## ADDENDUM 2

iB 01\_25\_26 – SCCOE Bus Drop Off

DATED OCTOBER 22, 2025

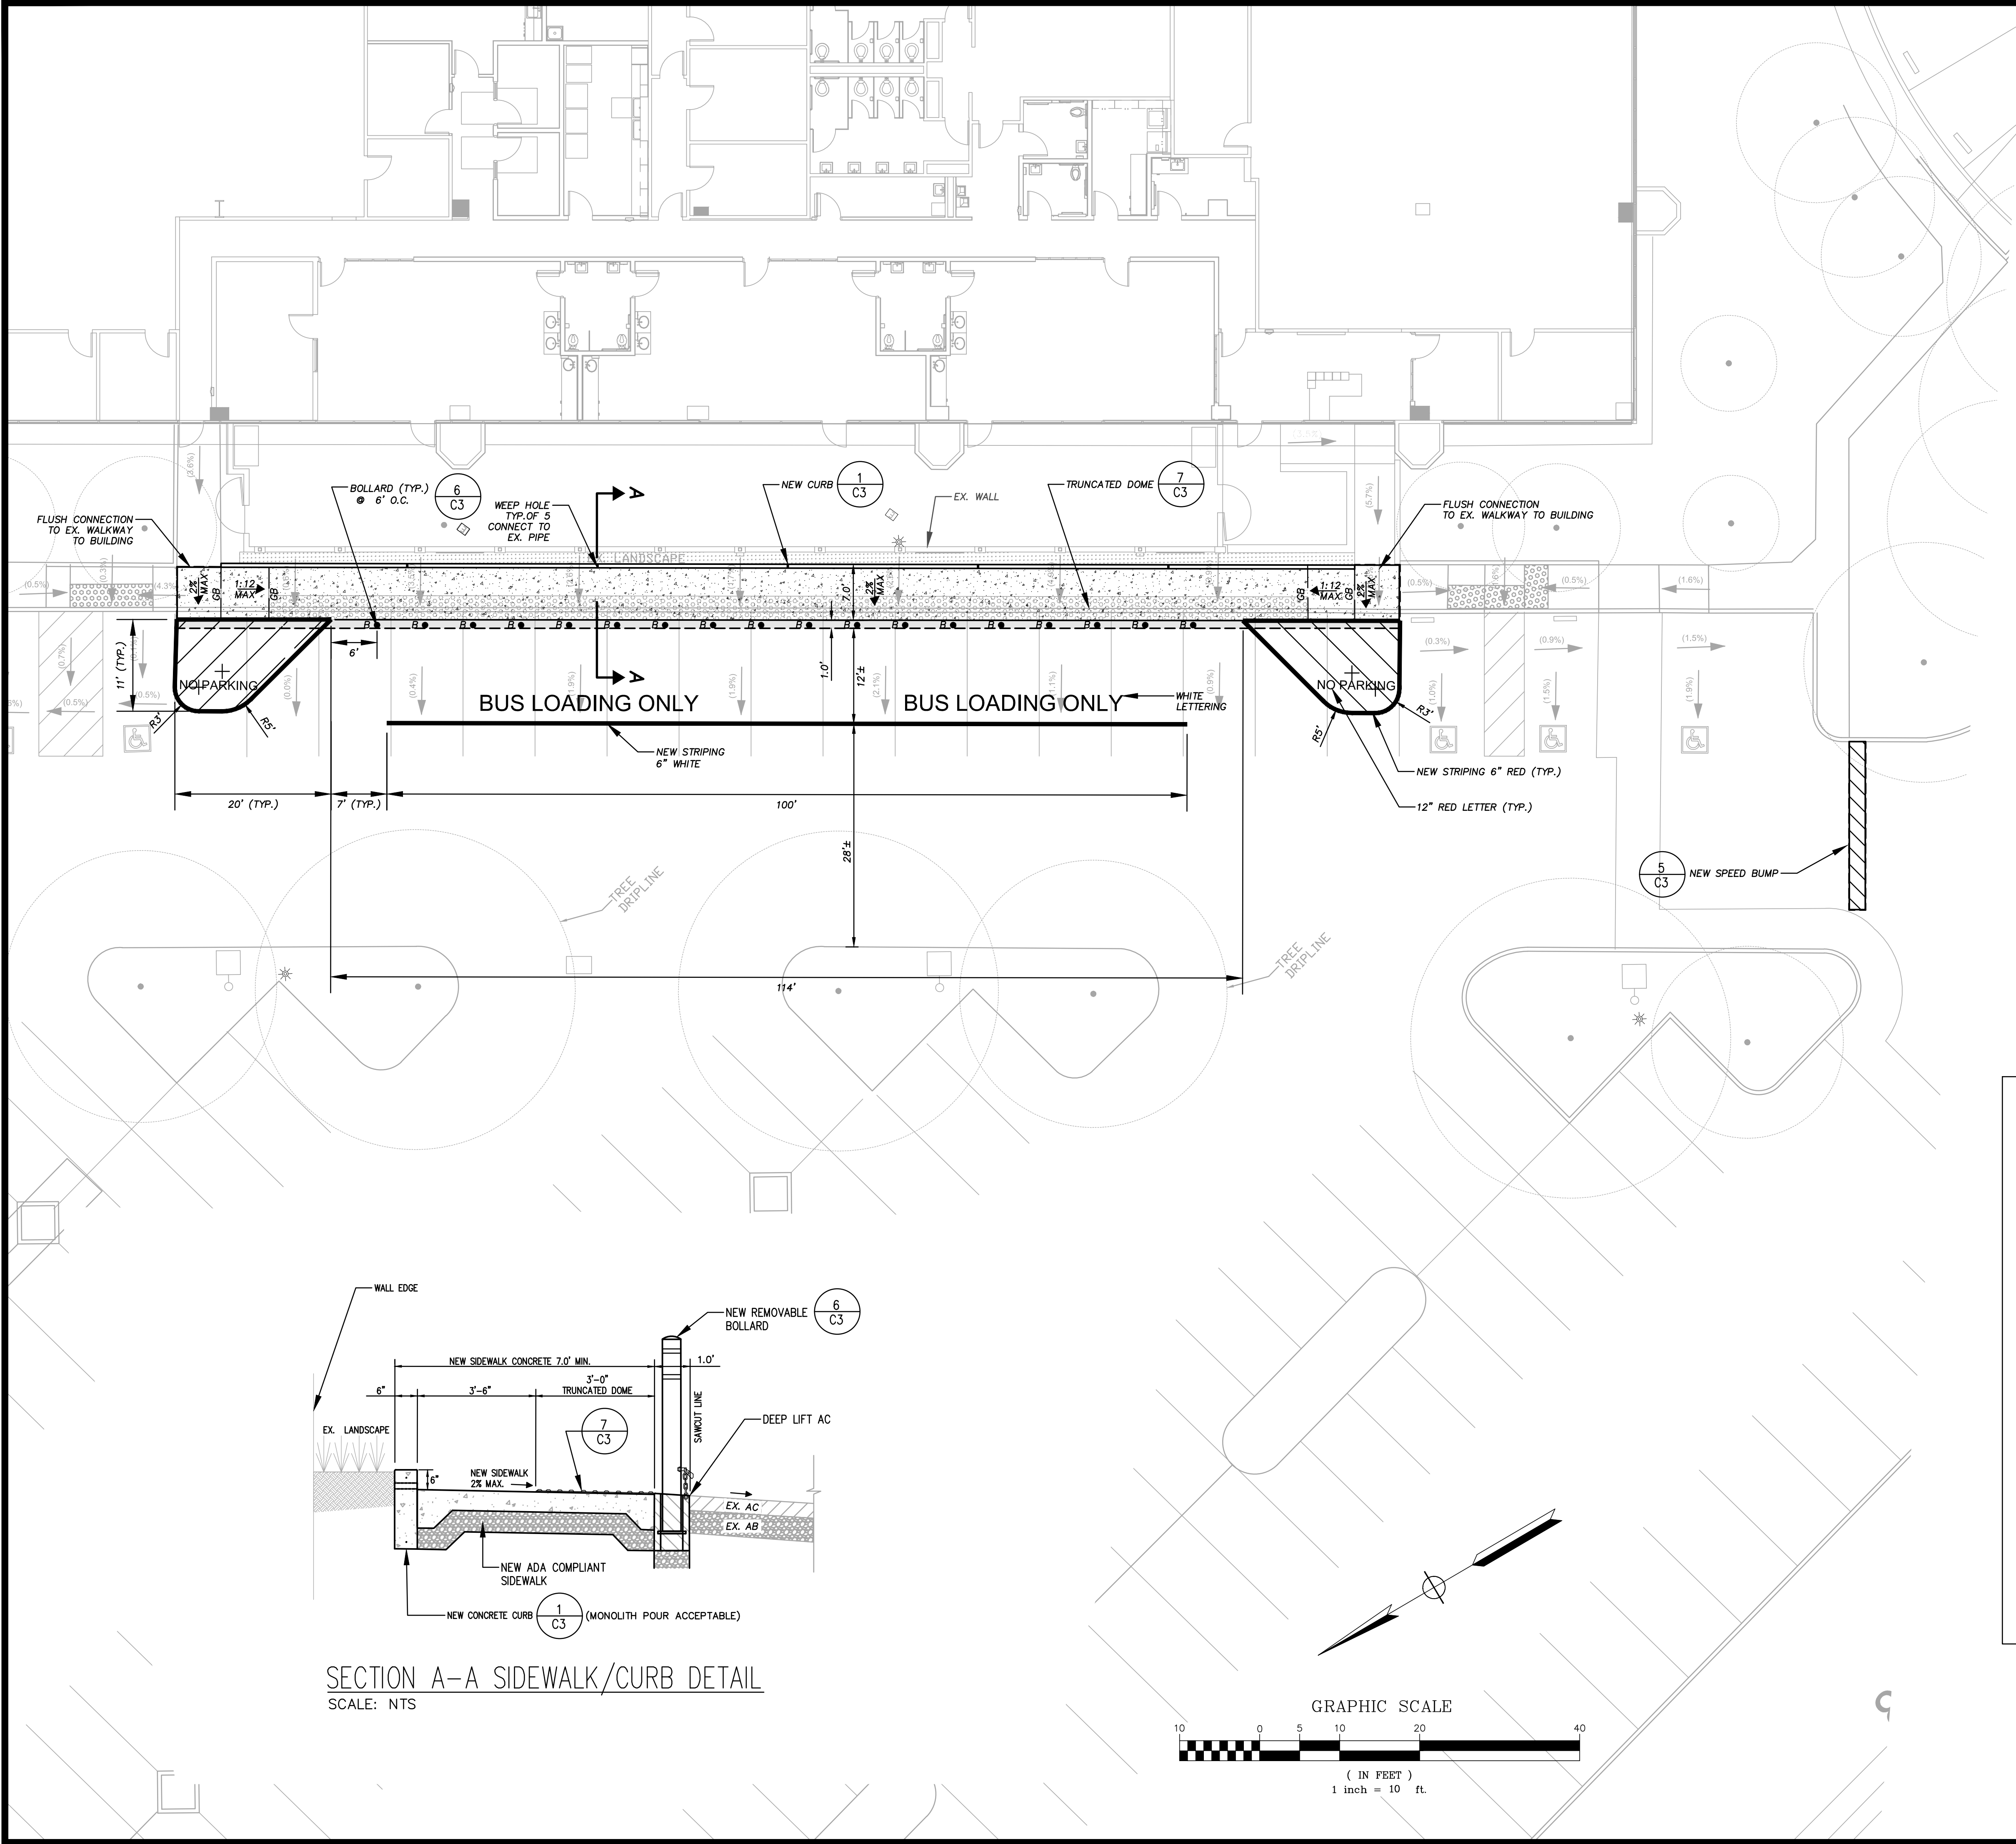
project and the fact that the majority of the scope is concrete-related, would you consider allowing C-8 contractors to bid on this project?	
Verify the scale on the plans; the plans call to be 1:20 and the dimension on the plan and the parking stall and look the scale is 1:10	<p>The City-approved civil plans issued under Addendum No. 1 remain the official bid documents for this project.</p> <p>It has been noted that the scale shown on the civil plan sheets is incorrectly labeled as 1" = 20'. The correct scale is 1" = 10'.</p> <p>To assist with clarity, the Engineer has provided a set of the original drawings reflecting the correct scale. These drawings are being issued for reference only and are not to be considered revisions or replacements of the City-approved plans.</p> <p>All bids and work shall remain based on the City-approved plans as issued in Addendum No. 1.</p>

**GRADING AND PAVING PLAN**

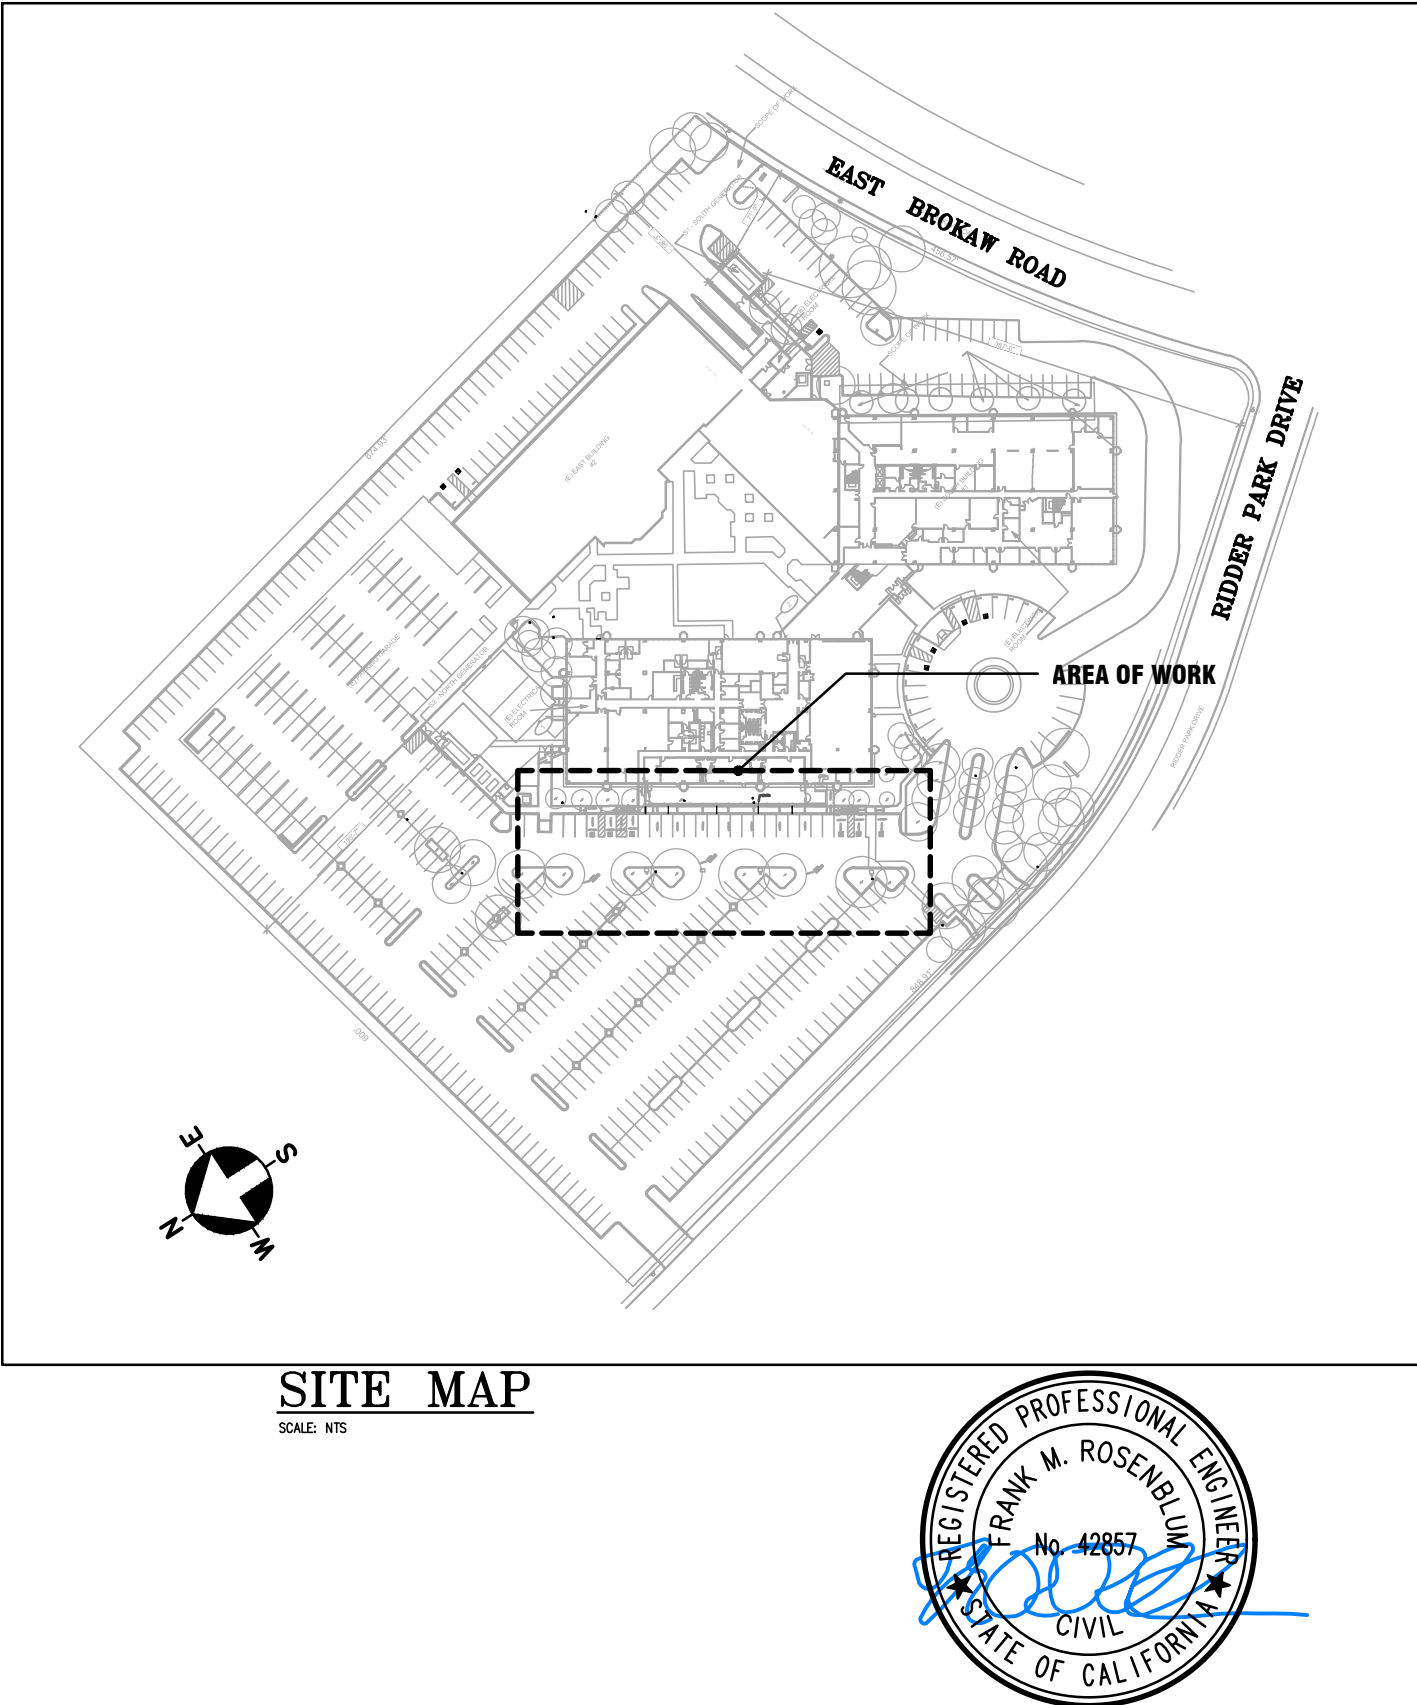
Regarding the removable bollard, detail 6/C3 – the plans call for the sleeves to be placed in a section of deep lift asphalt. Wouldn't a section of deep concrete be preferable?	The Bollard sleeve will be set in deep concrete; between the Bollards there will be a deep lift A/C pavement for 5 lineal feet.
I don't locate a bid bond form although I see it states, under the Required Bid Security, (3) a bond made payable to the SCCOE in the form set forth in the Contract Documents. Can you please forward the form?	The Bid Bond Form was included in Addendum 1 sent on October 10, 2025.
The bid forms did not include the bid bond form. Can we have our Surety Co. use their bond form?	The Bid Bond Form was included in Addendum 1 sent on October 10, 2025.
In the NTB, it specifies only an A license to bid on this project. Given the size of the	Contractor Classification A General Engineering Contractor
